Landmarks & Urban
Conservation Commission

Agenda Number: 4
Case No.: 17-LUCC-50030
Project # 1004971
November 8, 2017

Staff Report

Agent	Efthimios Maniatis	Staff Recommendation <i>Approval of Case # 17-LUCC-50030, Project #1004971, a request for a Certificate of Appropriateness for exterior fountain based on the Findings beginning on page 9 and subject to additional Recommendations on page 11.</i> Leslie Naji, Senior Planner Staff Planner
Applicant	Kathleen Chavez	
Request	Certificate of Appropriateness for exterior fountain	
Legal Description	Tract 182, MRGCD Map 38	
Address/Location	205 Romero St. NW	
Size	0.18	
Zoning	H-1	
Historic Location	Old Town Historic Zone

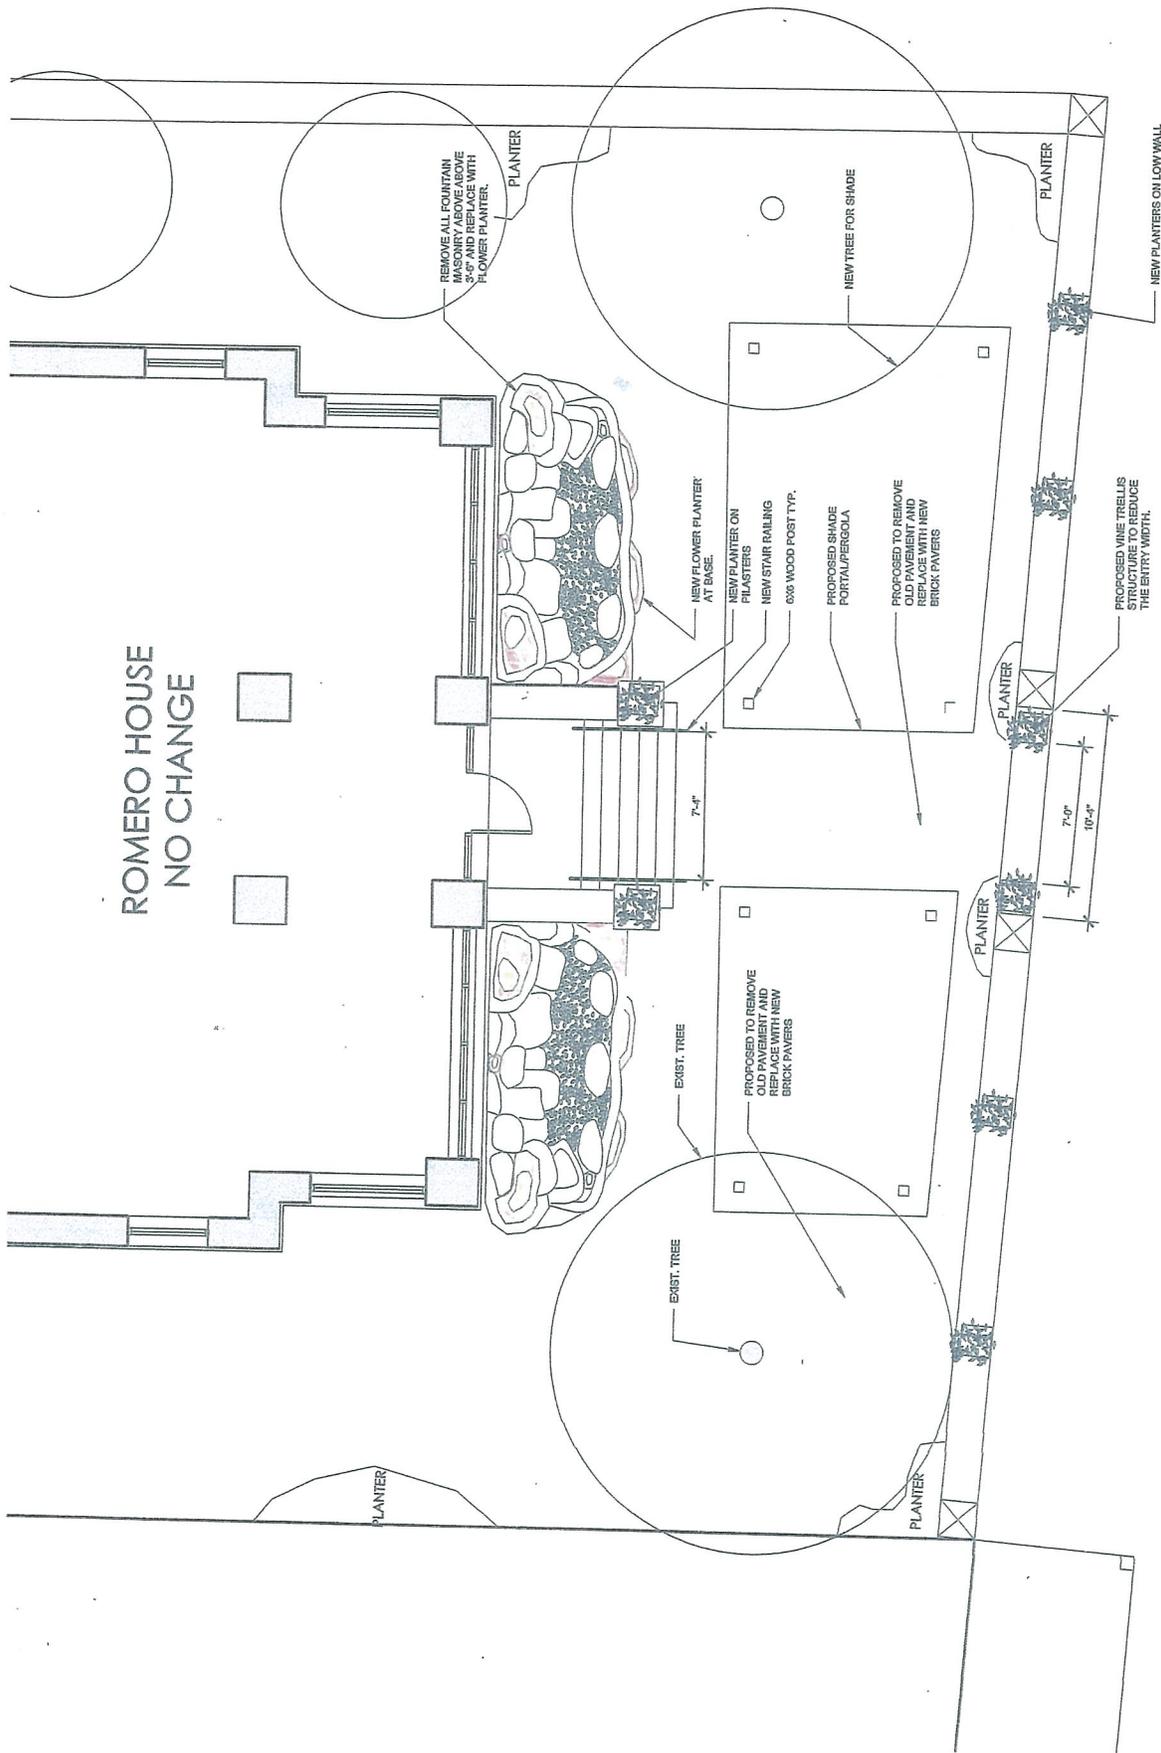
1. to maintain the existence of the fountains because it is vital to have them for the economical success of the property. It is proven that people visit this property more that ever before, because of the excitement the fountains provide. We are planing to reduce the height so to not be an abstraction to the building and introduce planting so to look like planters in front of a building like the way it was, also the church to the north has similar treatments in front of the buildings.

2. To reduce the 10'-4" opening at front o 7'-0" by introducing trellis with vines, vertically.

3. Introducing planting beds as needed thru out and a new large shade tree at the right as was in the past.

4. Introducing two shade structures with space between them so the entry of the building is visible from the street, the structures will be in think wood and metal (if needed) in off white stains, OR rusted darker stain colors let the board to select. The character will be to the 1915 period (or what ever the board prefers). The height is 10'-0" to be aliened to the window mullion. All building have a portal or a shade structure in front of them without taking away the importance of the building.

5. repave the entire front yard with brick.

6. Providing planters on the front yard wall. to a) allow the public to sit on and observe the Plaza and b) to be a some enclosure to the people who are enjoying the front yard by siting on the tables.
